Access Compliance Report Public Rights-of-Way (Curb Ramps)

Main Street: **BROWNING_AVE** Cross Street: **RAINBOW_DR** Location: **SE**

ADA ID: **RPRK211006120205** Ramp Type: **Type 1 - Perpendicular Diagonal** Initial Pass/Fail: **Fail** Overall Compliance: **No** Severity Score: **32**

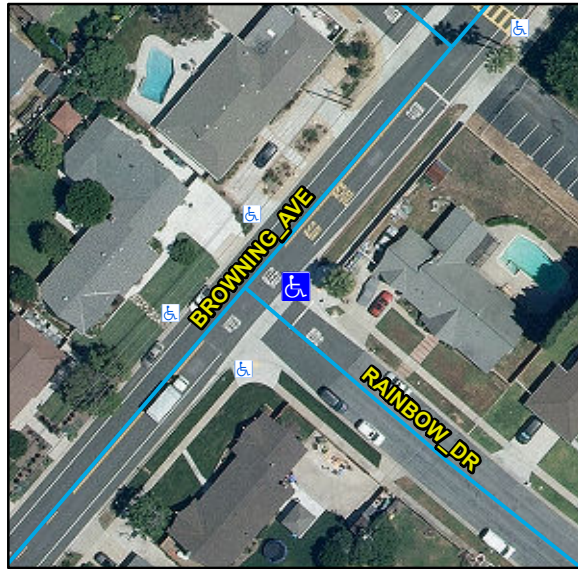
Compliance	Description	Data	Compliance	Description	Data
N/A	Ramp Length (in)	78	N/A	Flare Type LT	
Yes	Ramp Width (in)	48			N/A
No	Ramp Run Slope (%)	13.6	N/A	Flare Slope LT (%)	N/A
No	Ramp Cross Slope (%)	2.8	N/A	Flare Traversable LT	N/A
N/A	Landing Present	N/A	N/A	Flare Type RT	
N/A	Landing Length (in)	N/A			N/A
N/A	Landing Width (in)	N/A	N/A	Flare Slope RT (%)	N/A
N/A	Landing Run Slope (%)	N/A	N/A	Flare Traversable RT	N/A
N/A	Landing Cross Slope (%)	N/A	N/A	DWS Provided	N/A
N/A	Landing Movement Obstructed?	N/A	N/A	DWS Contrast	N/A
	Landing Movement Type	N/A	N/A	DWS Length (in)	N/A
N/A	Landing Shared	N/A	N/A	DWS Full Width	N/A
N/A	Clear Space	Yes	N/A	DWS Offset Left (in)	N/A
N/A	Clear Space To Crosswalk (in)	N/A	N/A	DWS Offset Right (in)	N/A
N/A	Marked Crosswalk 1	No	N/A	Marked Crosswalk 2	No
	Crossing 1 Direction	N		Crossing 2 Direction	W
	Marked Crosswalk 1 Width (in)	N/A		Marked Crosswalk 2 Width (in)	N/A

N/A	Ramp Inside Crosswalk 1	N/A	Yes	Ramp Inside Crosswalk 2	N/A
	Crossing 1 Slope (%)	14.1		Crossing 2 Slope (%)	12.4
	Crossing 1 Cross Slope (%)	2.8		Crossing 2 Cross Slope (%)	0.4
N/A	Gutter Ponding	N/A	No	Curb Slope	14.1
Yes	Gutter Lip Height (in)	0		Road Run Slope (%)	2.4
N/A	Gutter Run Slope (%)	N/A		Road Cross Slope (%)	7.3
N/A	Gutter Cross Slope (%)	N/A			
Yes	Overall Surface Condition: Acceptable		Yes	Perp Joint Present	Yes
	Cross Gutter Present?	Yes		Spandrel Present?	Yes
	Replace Cross Gutter?	No		Replace Spandrel?	No

Remove & Replace Curb Ramp With Two New Directional Ramps or Equivalent.

R304.2.2, R304.5.3, STD 1115
